SUBDIVISION REVIEW SHEET

CASE NO.: C8-2016-0018.0A**P.C. DATE:** April 11, 2017**SUBDIVISION NAME:** Resubdivision of Lots 15 and 16, Post Road Addition**AREA:** 0.808 acres**LOT(S):** 3**OWNER/APPLICANT:** Bodhi Group, LLC
(Yusof Johnson)**AGENT:** Land Answers, Inc.
(Jim Wittliff)**ADDRESS OF SUBDIVISION:** 232 Lessin Lane**GRIDS:** M23**COUNTY:** Travis**WATERSHED:** East Bouldin**JURISDICTION:** Full**EXISTING ZONING:** SF-3-NP**NEIGHBORHOOD PLAN:** Dawson**PROPOSED LAND USE:** Single-Family

SUBJECT: C8-2016-0018.0A Resubdivision of Lots 15 and 16, Post Road Addition

FINAL PLAT OF
RESUBDIVISION OF LOTS 15 AND 16, POST ROAD ADDITION

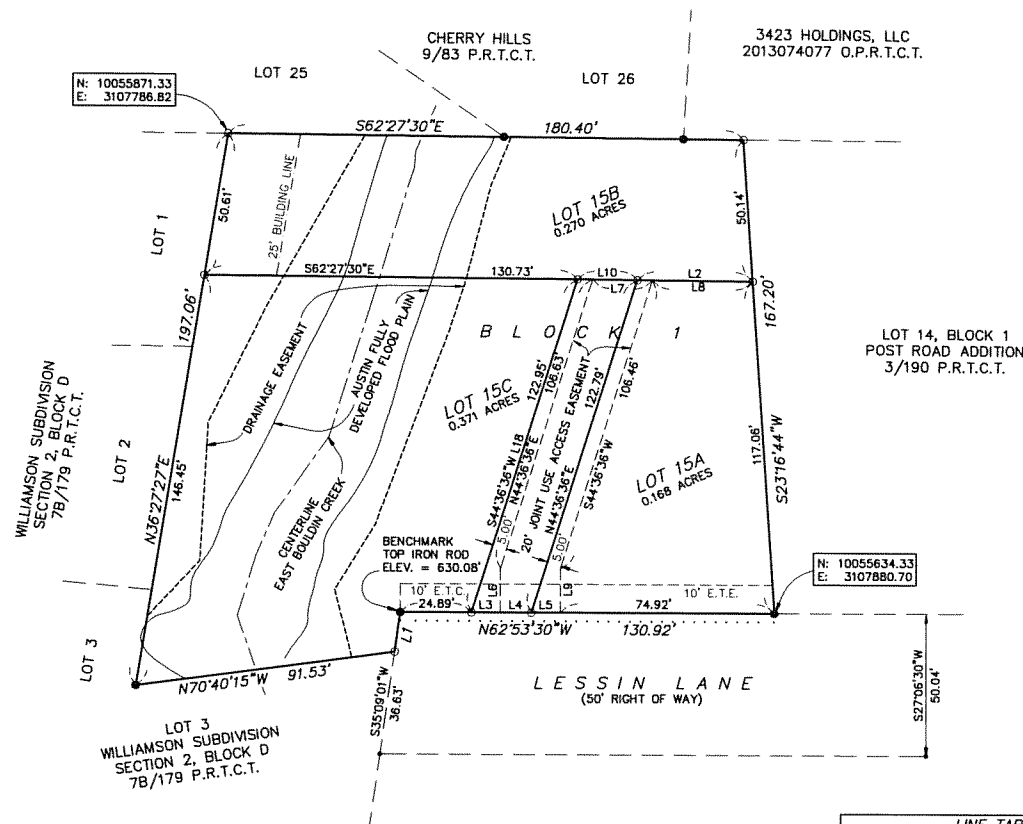
The applicant for the above referenced subdivision application has requested a variance from Section 25-4-175(A)(2) of the Land Development Code to utilize a flag lot design for a resubdivision creating three residential lots with one flag lot. In reviewing the variance request, staff evaluated the request based upon the criteria below, (see criteria and staff response):

The applicant has met with Austin Fire Department review staff and AFD staff has determined that the flag lot configuration proposed will not inhibit accessibility for emergency responders.

The applicant has provided a driveway and utility plan to reviewers for the City of Austin Water and Wastewater review and Austin Energy Departments. The reviewers have determined after review of the utility/driveway plan that there is adequate room to provide utility service to both lots and utilities will not cross the proposed new lot lines.

The applicant has provided a tree survey to arborist staff with the City of Austin and the arborist have no objections or further recommendations.

The plat proposes a flag lot that has a size comparable to existing lots on Lessin Lane. The flag lot would also be compatible with the two-unit residential or secondary apartment uses on the subdivision block.

Based upon review of these criteria, staff **recommends** the variance request to develop a flag lot as a part of this resubdivision request.
